Arkay Knit Dyeing Mills Ltd.

28 March 2022

Observations

Figure 6.16: Assigned Live Load on 3rd Floor (part 2) (psf)Figure 6.18: Assigned Live Load on 4th Floor (part 2) (psf)

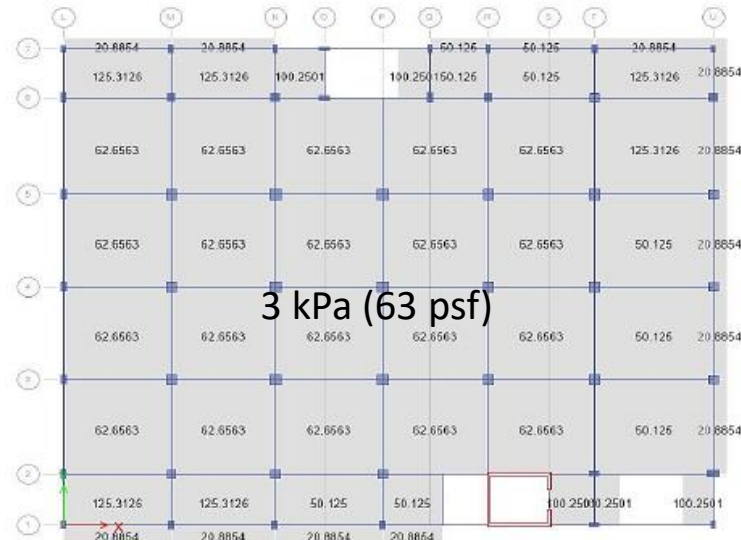
As per BNBC 2020 the minimum floor live load for the light garments manufacturing is 4 kPa.
3 kPa live load considered for the 3rd and 4th floor.

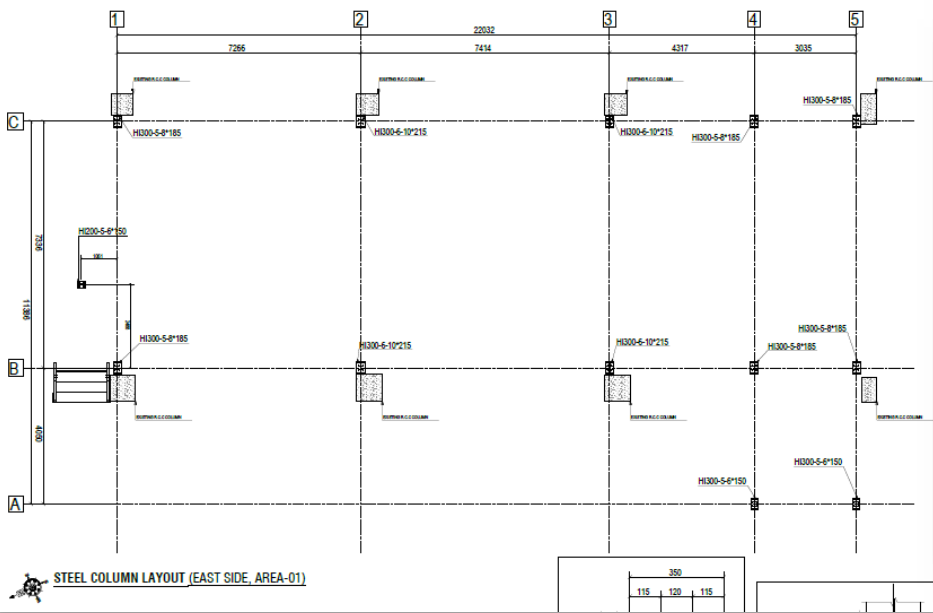
According to the design report external torsional irregularity found at ground floor of the building-1. But no remedial actions were suggested in the design report. Building engineer is required check the necessity and prepare proper remedial action for the torsional irregularities.

Column layout plan of Steel Mezzanine floor

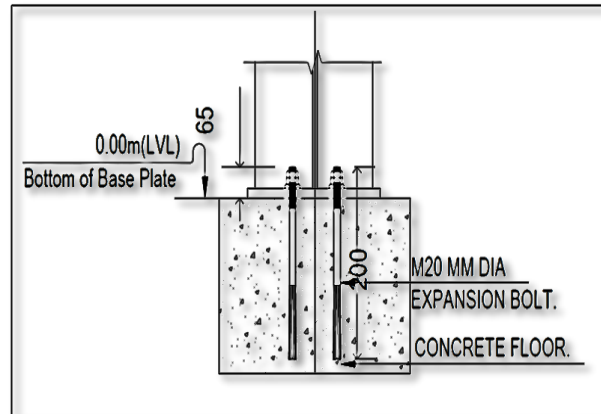
Columns of mezzanine floor supported on the ground slab of the Building 1. In design report the foundation adequacy of the mezzanine floor not included. Building engineer is required to check the punching shear capacity of the ground slab of the Building 1.

Water ponding at the roof of Building-1

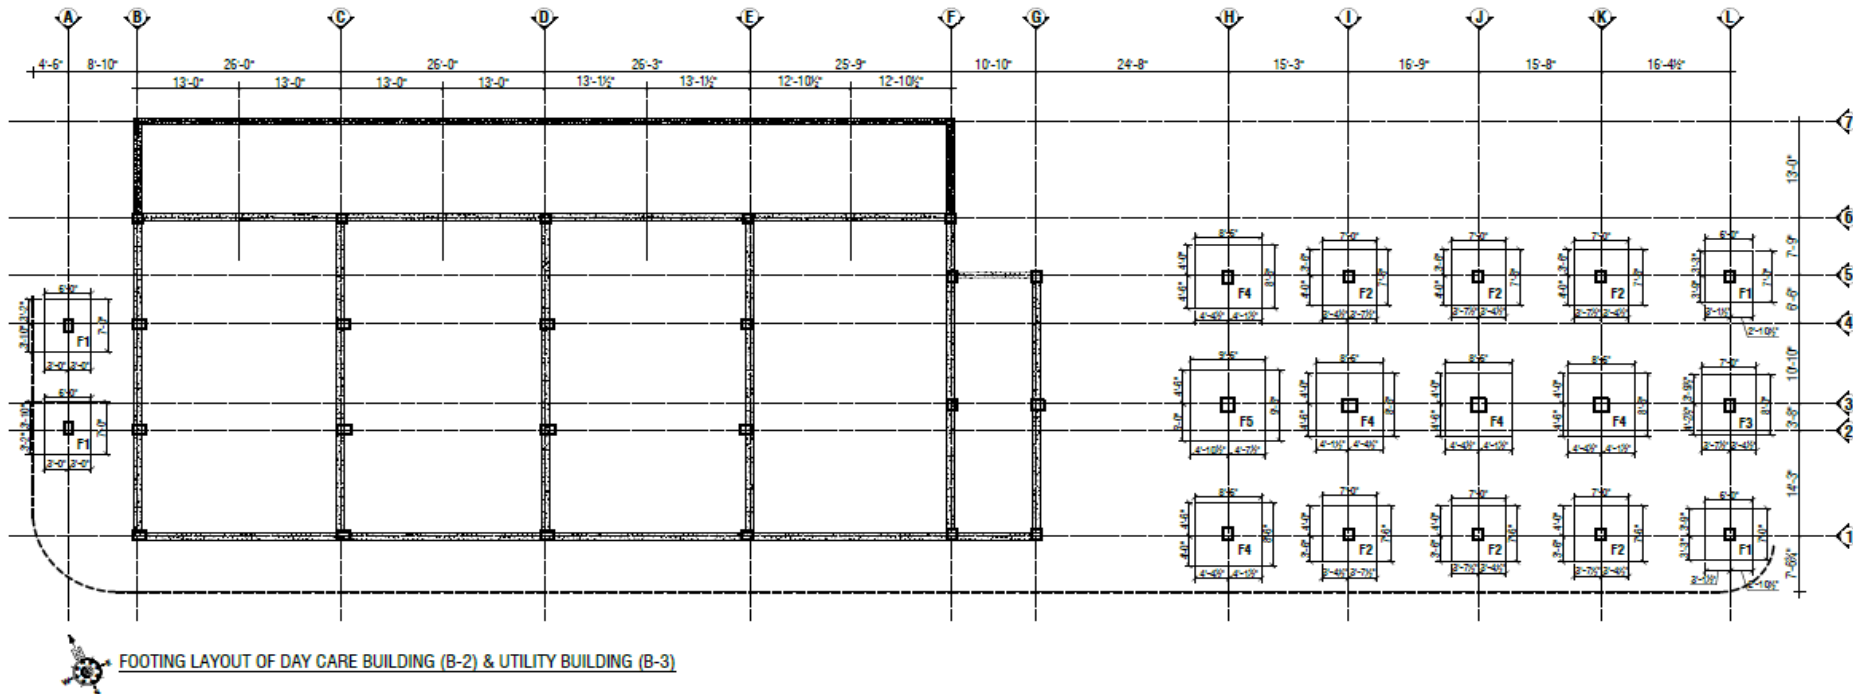
Water clogging was observed on roof of the buildings due to leakage of pipeline & improper drainage system. Building engineer is required to improve the roof drainage system & to repair the leakage of pipeline.

Building-5 : Irregular in shape

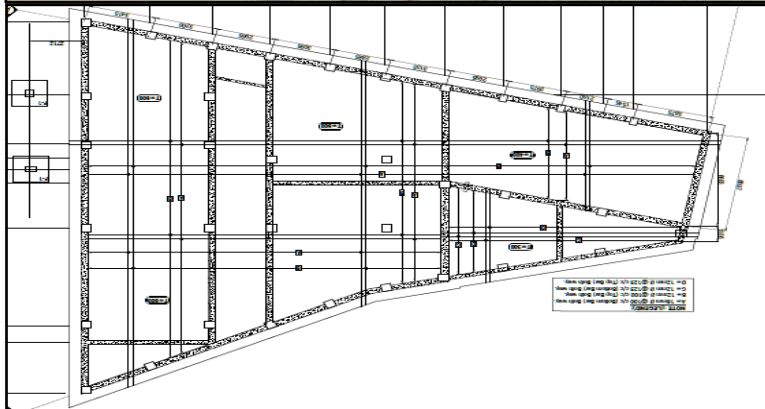
The building shape is geometrically irregular. Due to lateral forces, the building might be affected for torsional irregularities. In design report, extreme torsional irregularities found. Building engineer is required to suggest remedial action for the torsional irregularities.
